Minute No. 248
Report – Standing Policy Committee on Property and Development – February 2, 2023

Item No. 17 **Zoning Agreement Amendment – Canterbury Crossing Properties abutting CN Railway to the North, East of Ravenhurst Street (Transcona Ward)**
File ZAA 7/2022

Title: ZAA 7/22 – Canterbury Crossing properties abutting CN Railway to the north, east of Ravenhurst St.

SUBJECT: For consideration at the public hearing for a Zoning Agreement Amendment to revise clause six (6) and eight (8) of Zoning Agreement DASZ 10/2017.

Appendix B: Map of proposed Canterbury Crossing berm height and rail setback amendment

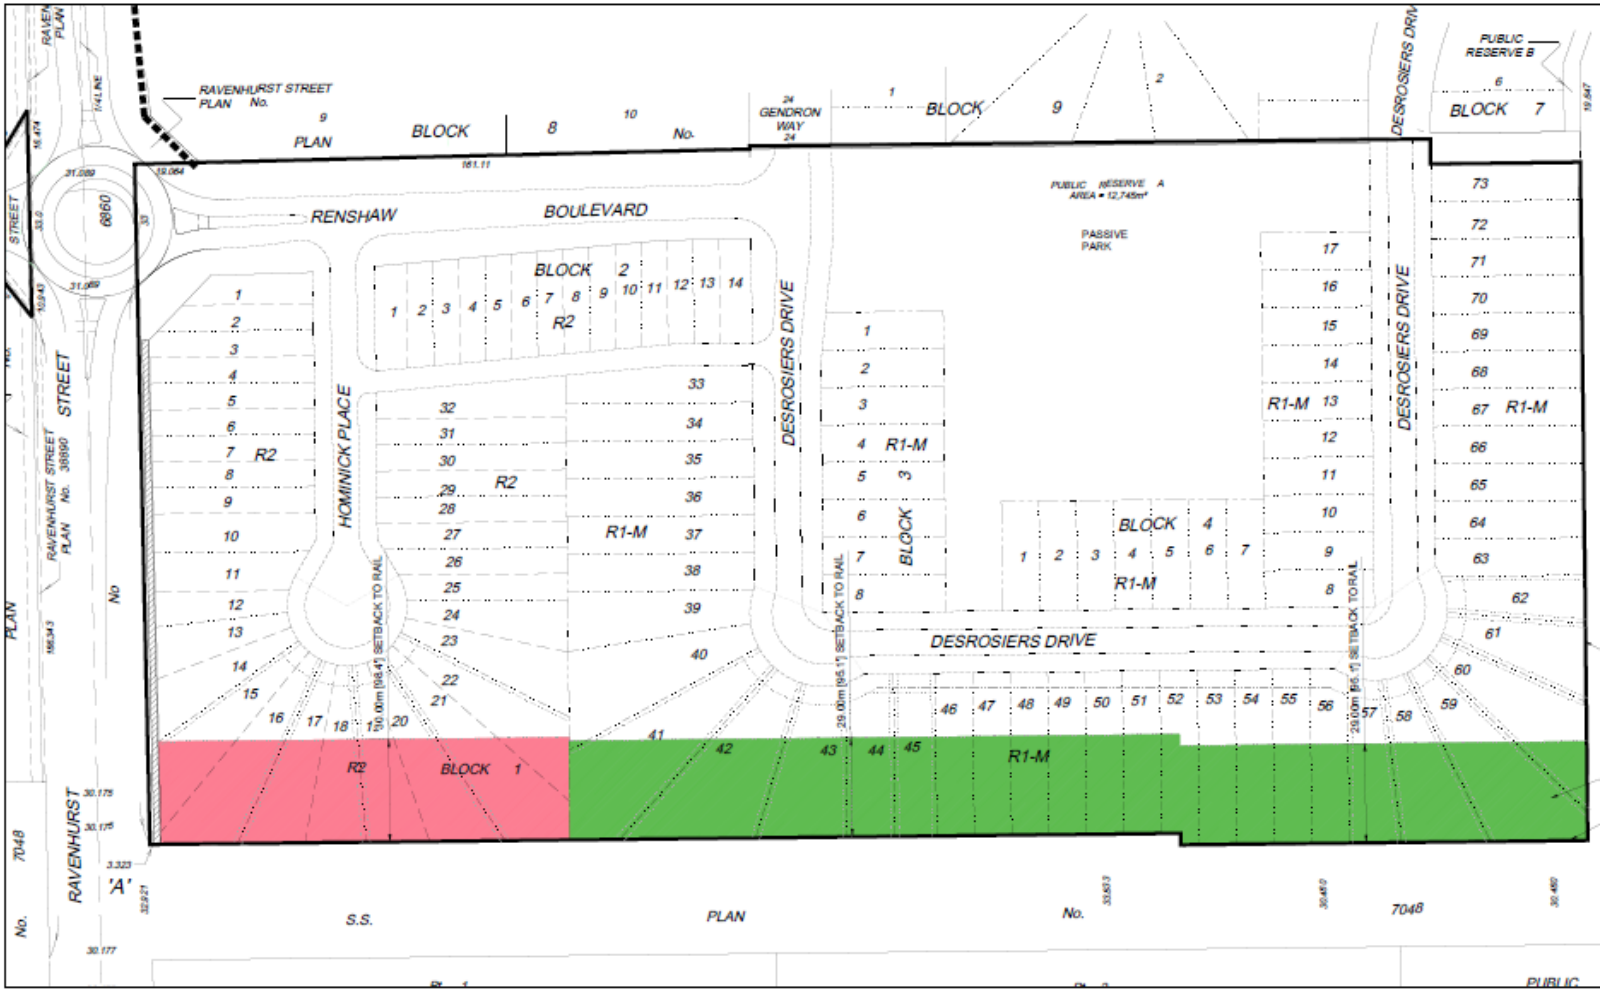
- In order to reclaim the lost metre of developable area, the applicant has requested to amend the subject zoning agreement to enable the following:
    - Increase the required berm height to 3.5 metres for lots 41-59 Block 1 PLAN 70448 WLTO IN SE ¼ 3-11-4 EPM

- Enable a proportionate reduction in required setback to permit a 29 metre setback from the rail line to habitable space on lots 41-59 Block 1 PLAN 70448 WLTO IN SE ¼ 3-11-4 EPM

- The applicant is proposing a one (1) metre reduction in the 30 metre setback in exchange for a proportionate increase in berm height of one (1) metre to enable their proposed development plan.
- The Public Service finds this alternative to be equivalent with the original intent outlined in the existing zoning agreement.
- This alternative approach is consistent with the Federation of Canadian Municipalities (FCM) *Guidelines for new development in proximity to railway operations.*

b) On lots 16-21 Block 1 PLAN 70448 WLTO in SE 1/4 3-11-4 EPM, a berm 2.5 metres (8.2 feet) in height and with a gradient no steeper than 3:1 (the "Railway Berm");

c) On lots 41-59 Block 1 PLAN 70448 WLTO in SE 1/4 3-11-4 EPM, a berm 3.5 metres (11.5 feet) in height and with a gradient no steeper than 3:1 (the "Railway Berm");

d) A uniform noise attenuation fence, 2.5 metres (8.2 feet) in height (the "Railway Noise Attenuation Fence") constructed with fence posts 6 by 6 inches in size, with said fence posts spaced 6 feet apart on top of the entire length of the Railway Berm.

a) On lots 16-21 Block 1 PLAN 70448 WLTO in SE 1/4 3-11-4 EPM, provide a setback of no less than: 30 metres (98.4 feet) between the Railway and any habitable room or living space within a building located on that lot.

b) On lots 41-59 Block 1 PLAN 70448 WLTO in SE 1/4 3-11-4 EPM, provide a setback of no less than: 29 metres (95.1 feet) between the Railway and any habitable room or living space within a building located on that lot."
